Nomination Form
Anadromous Waters Catalog

Anadromous Waters Catalog Number of Waterway: 111-50-10300

Name of Waterway: Lena Creek ☑ USGS Name ☑ Local Name

Route Correction for Lena Creek (111-50-10300)

Left photo: Series of rocky cascades with a barrier falls in the background.
Right photo: Cascade along the barrier reach showing moss and bedrock substrate.

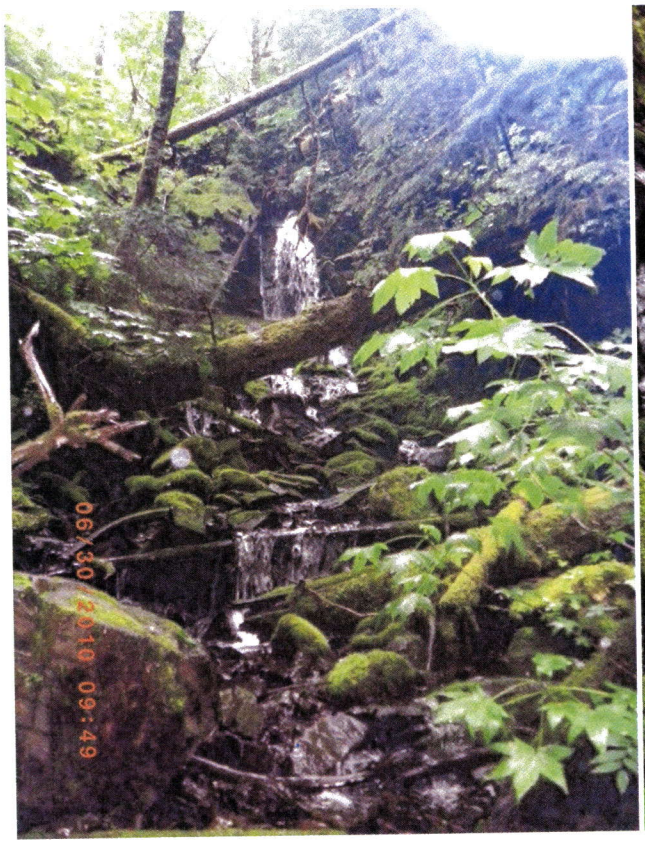
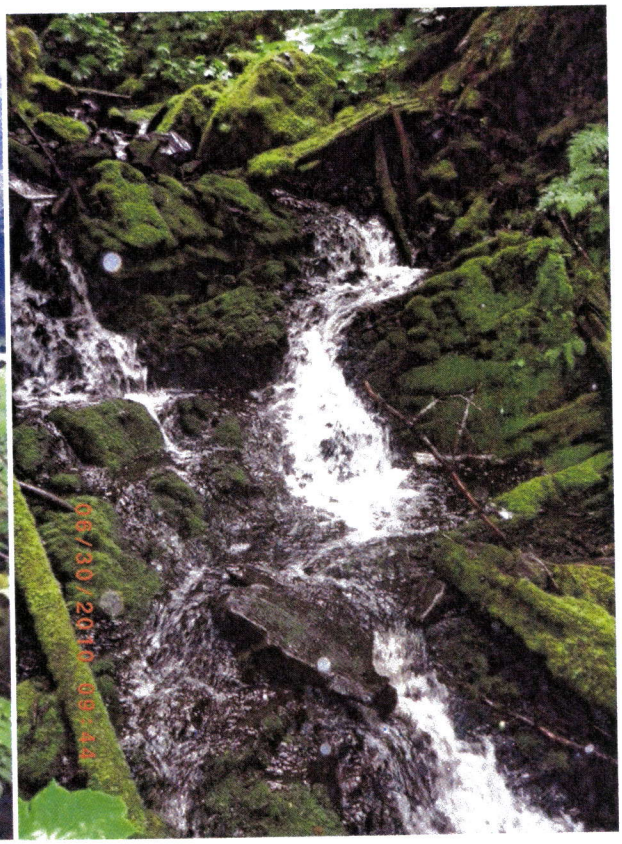
The cataloged route of Lena Creek was walked and tracked until a barrier to fish passage was encountered. There is a waterfall barrier with a 45-50% gradient over approximately 140 feet, upstream of the culvert passing under Glacier Highway. The following coordinates indicate the upper and lower extent of anadromous fish habitat in Lena Creek for species presently listed in the Anadromous Waters Catalog. The red outline on the included map indicates the route correction on Lena Creek.
